SYDNEY DEVELOPMENT CONTROL PLAN 2012 – APDG SITE BLOCK 4 (REVISED JANUARY 2016)

# DRAFT SYDNEY DEVELOPMENT CONTROL PLAN 2012 – APDG SITE BLOCK 4

# Schedule 1 – Amendment to Sydney Development Control Plan 2012

STREETS, LANES AND THROUGH SITE LINKS - OPTION B Figure 6.8A

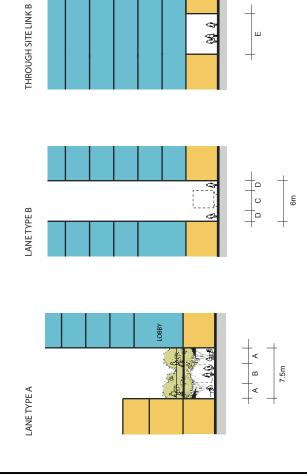
#### [6] Figure 6.8 Streets, Lanes and Through Site links

After Figure 6.8, insert Figure 6.8A as shown attached.

All seats, tables and umbrellas in the public domain must be removable (consistent with the concept of "naked streets" including minimal signage).

Laneway awnings must not have fixed elements or vertical screens.

Design of the public domain and lanes should prioritise pedestrian activities and provide an equitable clear path of travel, preferably adjacent to the building line.
